Objection to Planning Application No 2016/1479/P 'Restoration of historic garden' in Chester Gate
Application type: Full Planning Permission

Site: Chester Gate Gardens
Prepared by: Peter Sturgeon
Status: Final
Date: 08/06/2016

- 1.1 Motion has been appointed by the Chester Terrace Residents Association to undertake a review of the March 2016 Transport Statement prepared by Caneparo Associates in relation to the proposal to create a garden to the immediate north of 6 – 10 Cambridge Terrace.
- 1.2 Chester Gate is a single carriageway one way road that passes from Albany Street in the east to Outer Circle in the west. The proposals result in the reconfiguration of the western end of Chester Gate from two lanes to one and will require the stopping up of public highway to implement the scheme.
- 1.3 The review identified a number of issues and concerns with the latest proposals, which can be grouped under the following headings:
- ▶ Cumulative Impact;
 - ▶ Parking; and
 - ▶ Vehicle Access.
- 1.4 These topics are considered in detail in the following sections of this report.

Swept Path Analysis Using a 9m Refuse Vehicle - Proposed

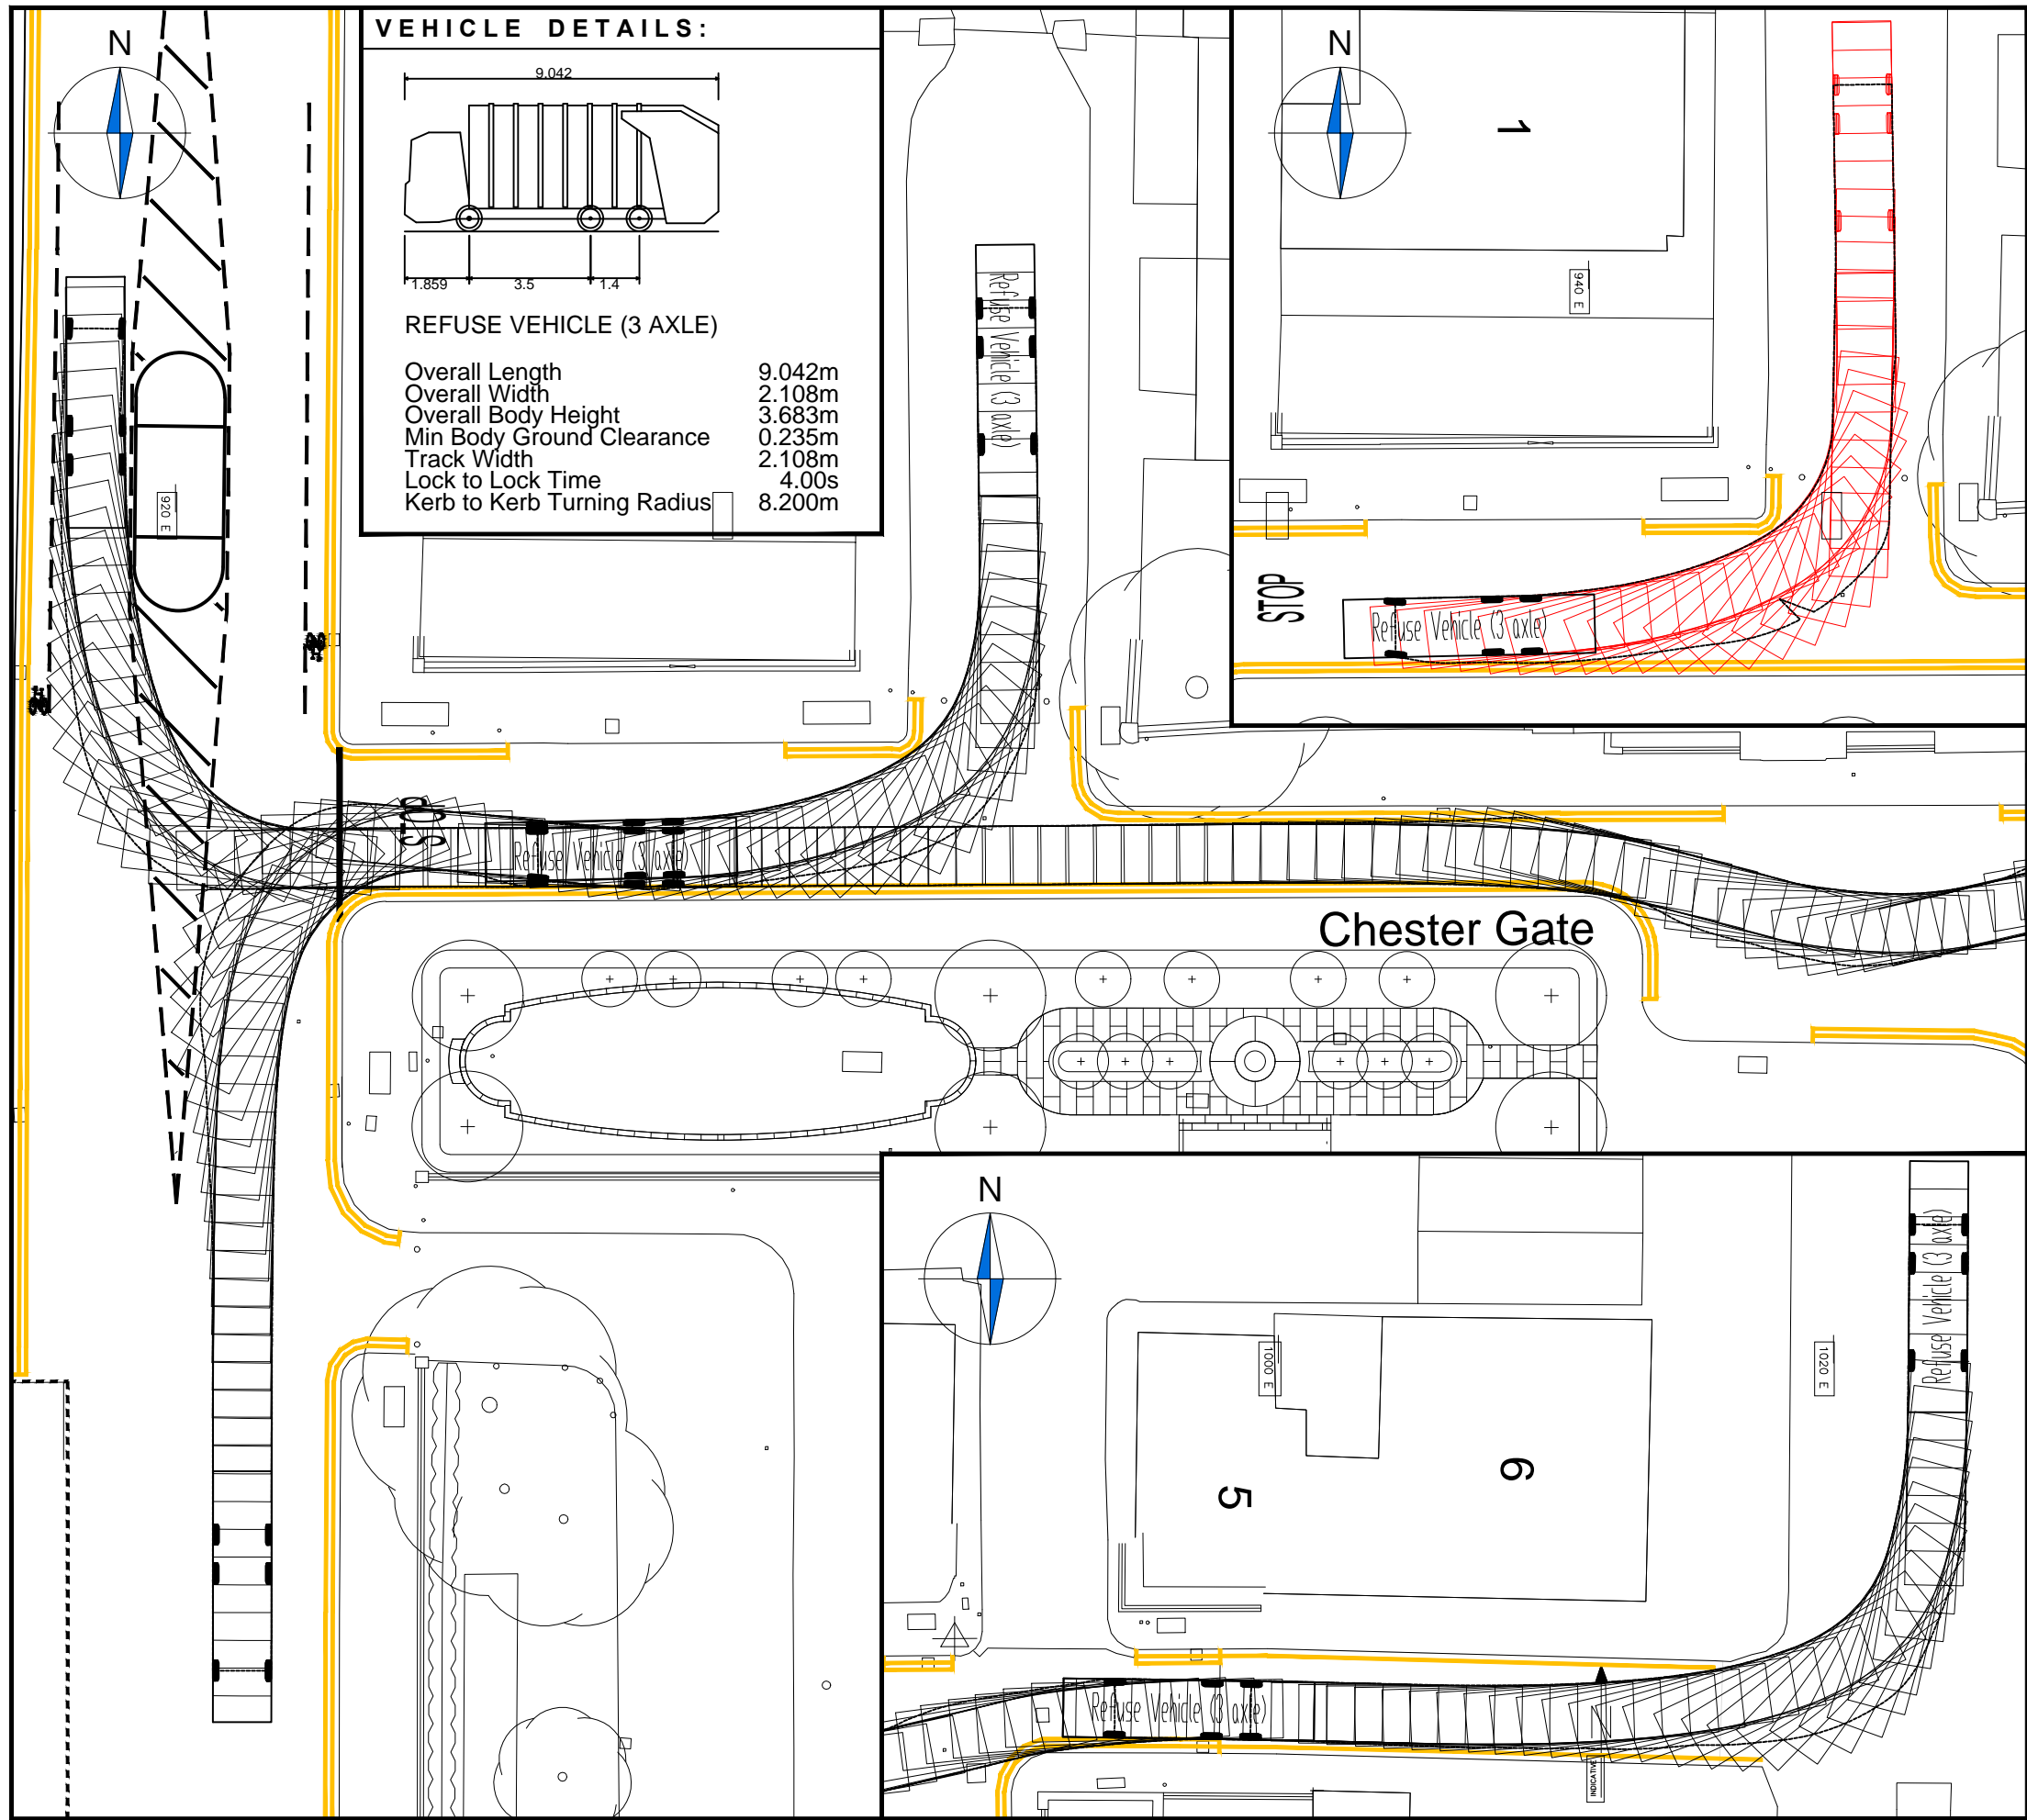
- 4.1 Swept path analysis has been submitted as a part of Caneparo Associates Transport Statement to demonstrate that a 9 metre refuse vehicle and Fire Tender can manoeuvre along Chester Gate with the proposed highway arrangement in place. A copy of this analysis is attached at **Appendix A** for reference. The swept path analysis shows that space around these vehicles when manoeuvring is very limited, with negligible clearance past footways, where in reality, there would be a likelihood that vehicles could overhang the footway when manoeuvring, resulting in potential for conflict and arising safety issues with pedestrians.

- 4.2 The plans provided do not show parked cars, so it is not possible to ascertain what clearance there would be between large vehicles and parked cars, however, it appears that any clearance would be very limited.

- 4.5 As noted, the swept path analysis in Caneparo Associates Transport Statement does not show parked cars and therefore it has not been demonstrated that cars would not obstruct large vehicles. Any analysis should also consider whether a large vehicle could pass another large vehicle stopped on Chester Gate delivering to properties in the area.

- 4.6 The Caneparo Associates Transport Statement includes the results of an Automatic Traffic Count (ATC), which provides a count of all vehicle movements on Chester Gate over the course of a week. Whilst signage at the entrance to Chester Gate advises that *"No trade or business vehicles except permit holders, taxis and for access to premises"*, the ATC data shows that a significant number of commercial vehicles use Chester Gate, with 635 two axle trucks or buses entering the street over the course of the week, 34 three or four axle rigid HGVs and 29 articulated vehicles, including 11 six axle combinations. These articulated vehicles and some of the rigid HGVs will be both longer and wider than the refuse vehicle and fire tender used in the submitted swept path analysis.

- 4.7 Whilst some of these vehicles may legitimately be accessing properties located off Chester Gate, it is likely that many are not and are accessing the street in contravention of the posted signage. However, as access by these vehicles does take place, consideration needs to be given to whether these vehicles will safely be able to negotiate their way along the street in future to ensure that the proposals would not result in the street becoming blocked or compromise the safety of existing road users and pedestrians.
